May 30, 2023

Re: Landmark Square Building 3 ZB Application #223-12

As discussed, we offer the following responses and updated materials pursuant to our review of the application materials with you on 4/1423 and subsequent discussions with LUB and TTP staff on 5/23/23.

BUILDING ELEVATIONS

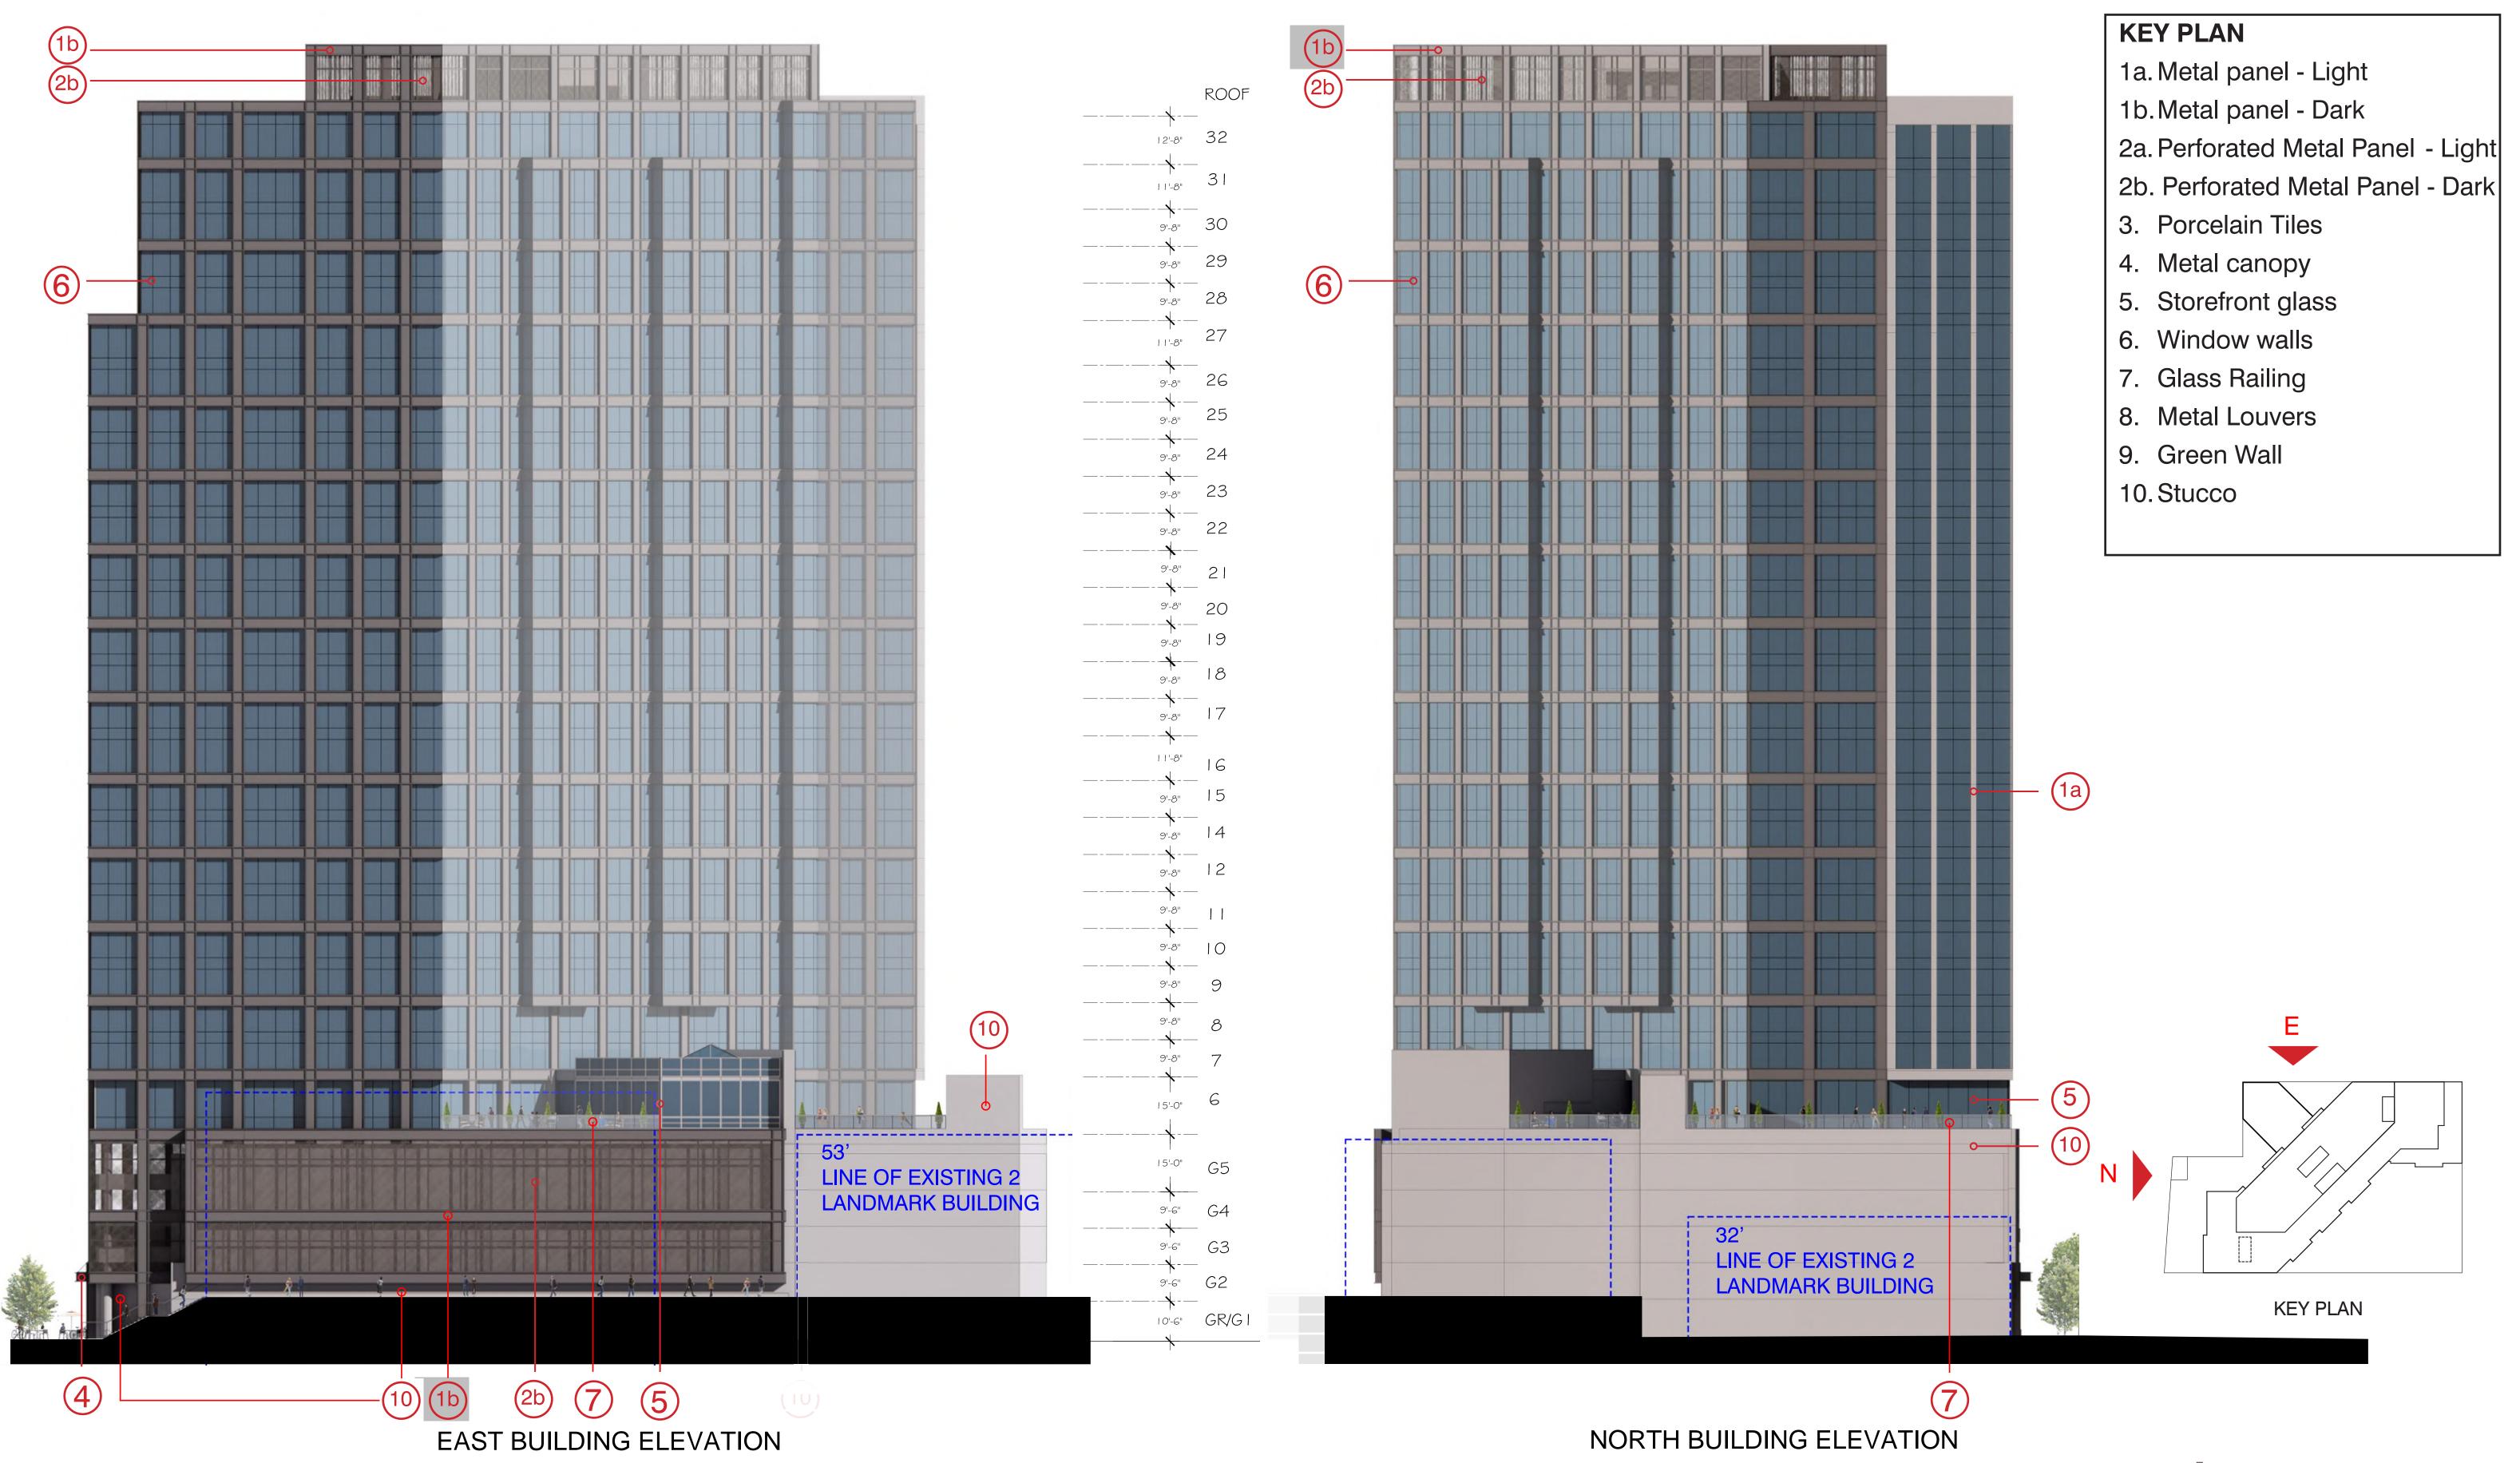
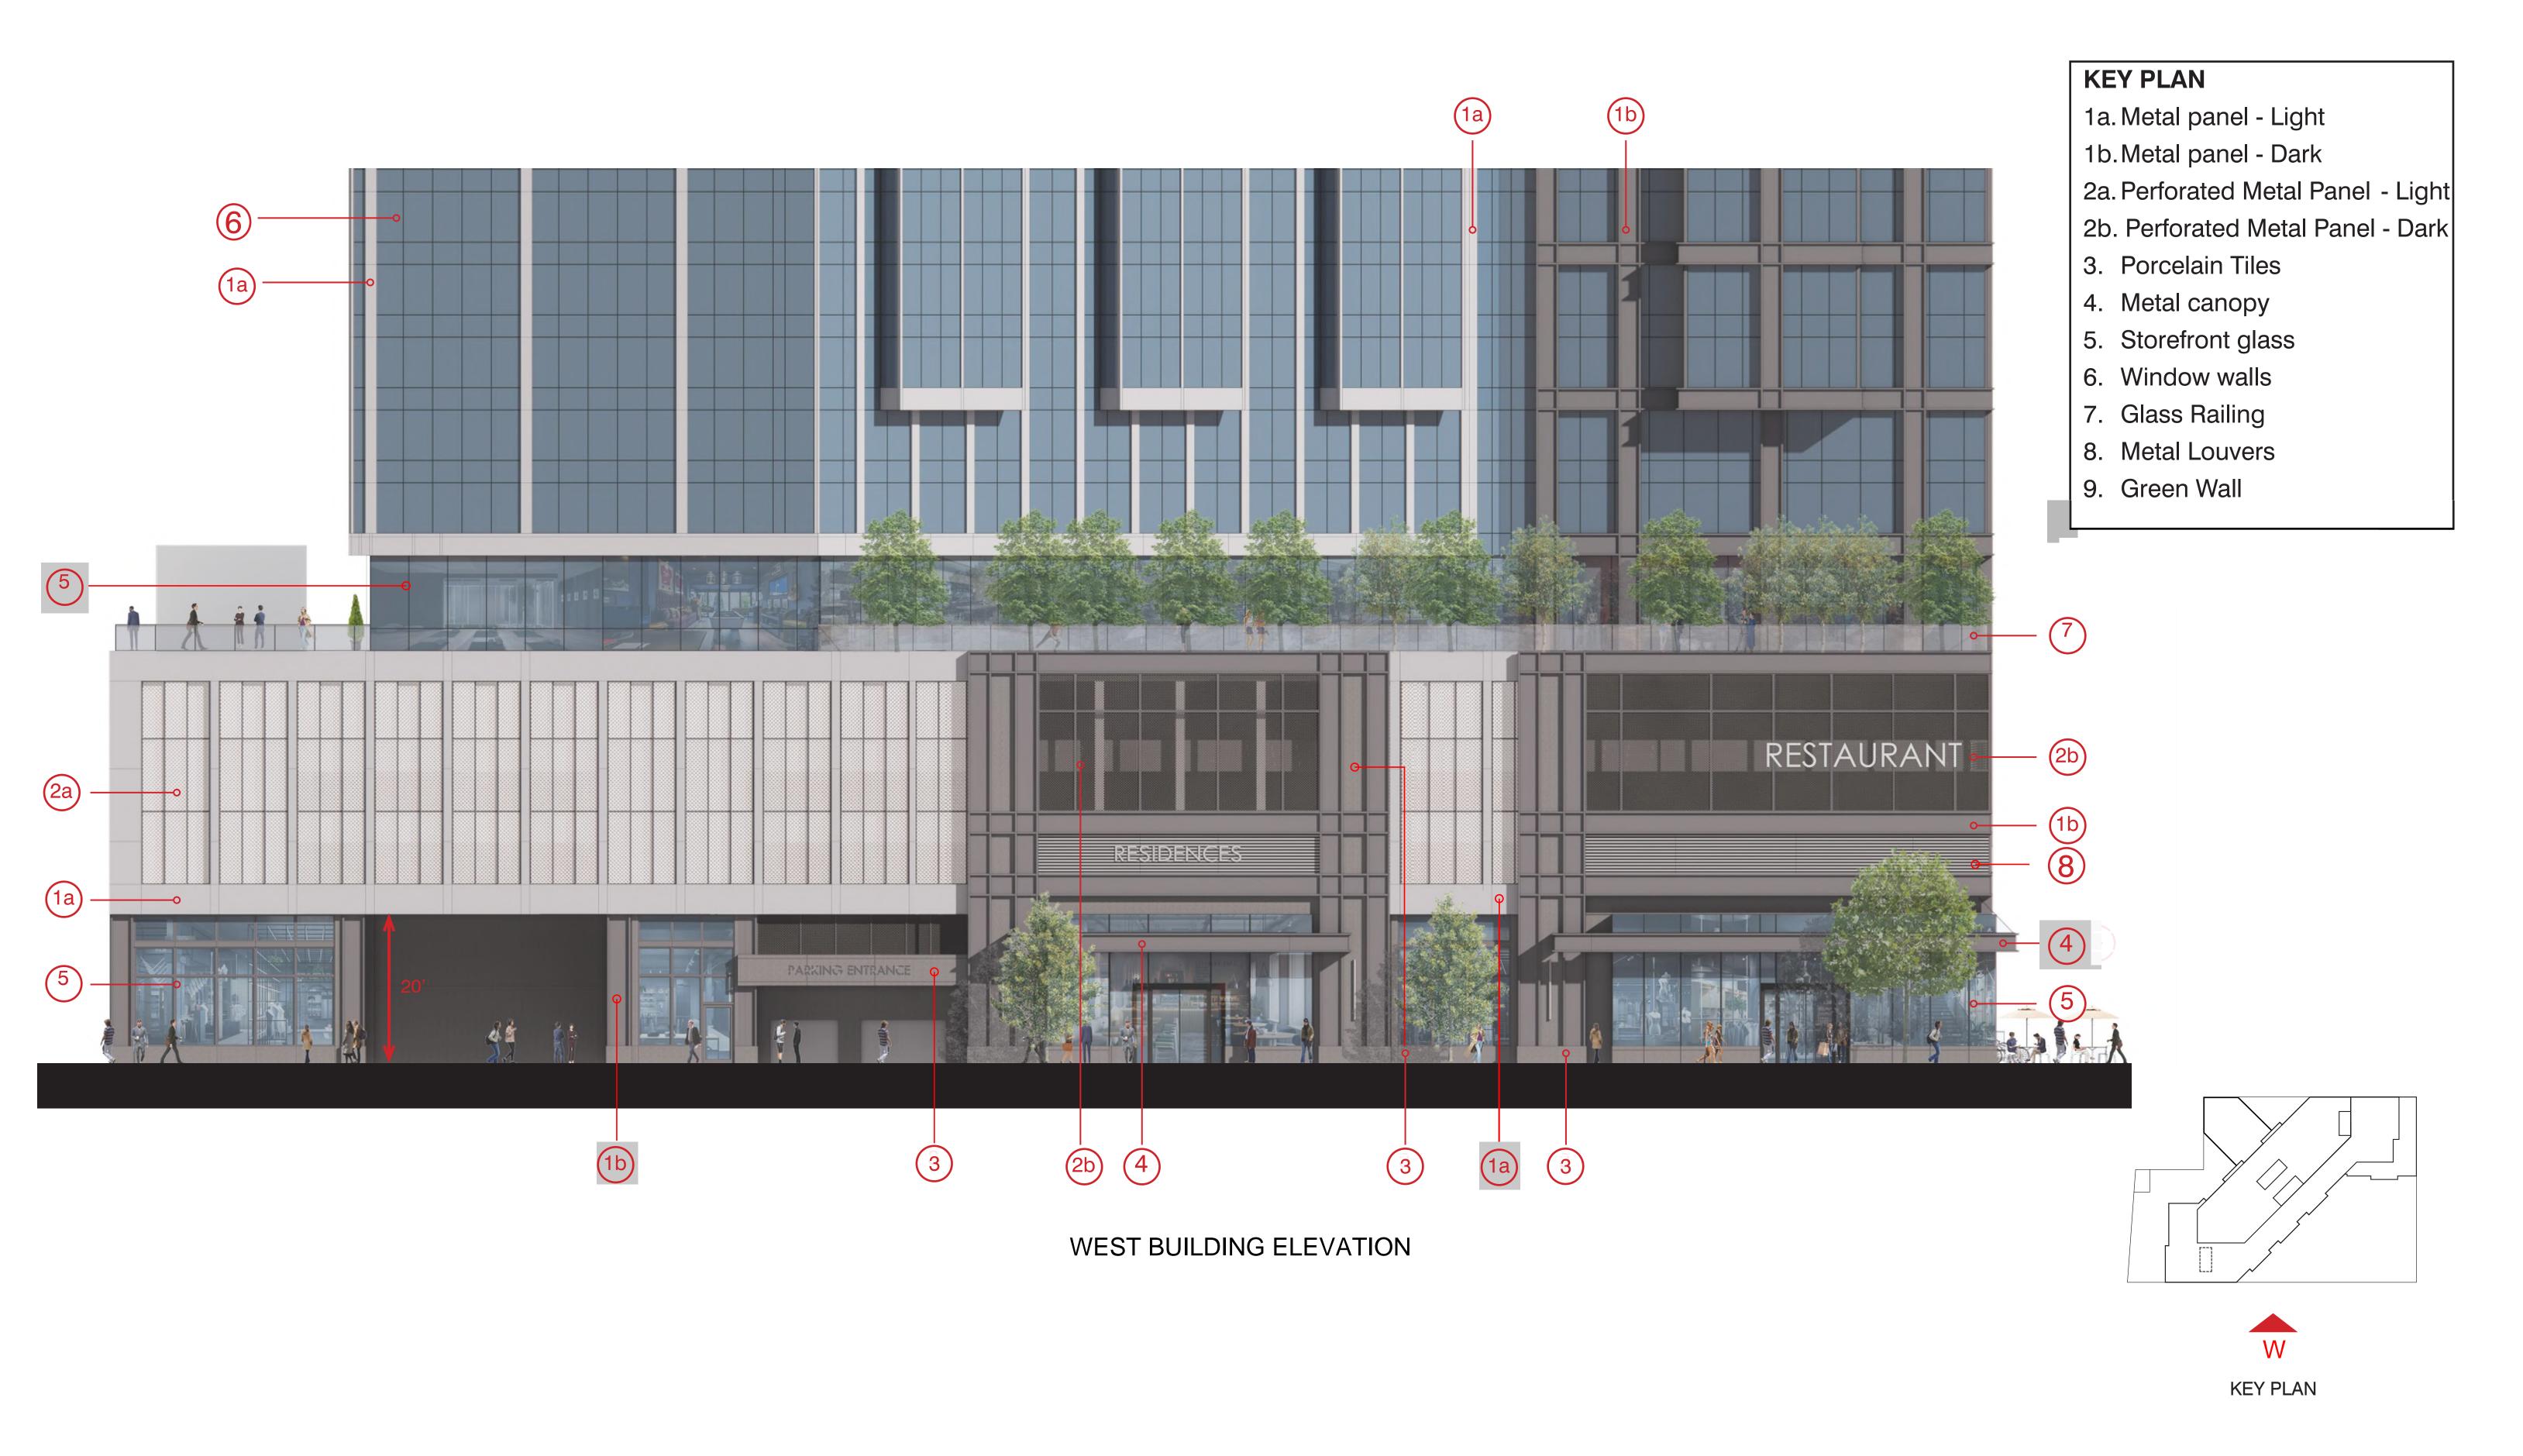
- b. Elevations revised to more clearly depict elements of each particular façade that are, in reality, set back or angled along a particular view.
 - c. Additional detail and real-life images are included to depict:
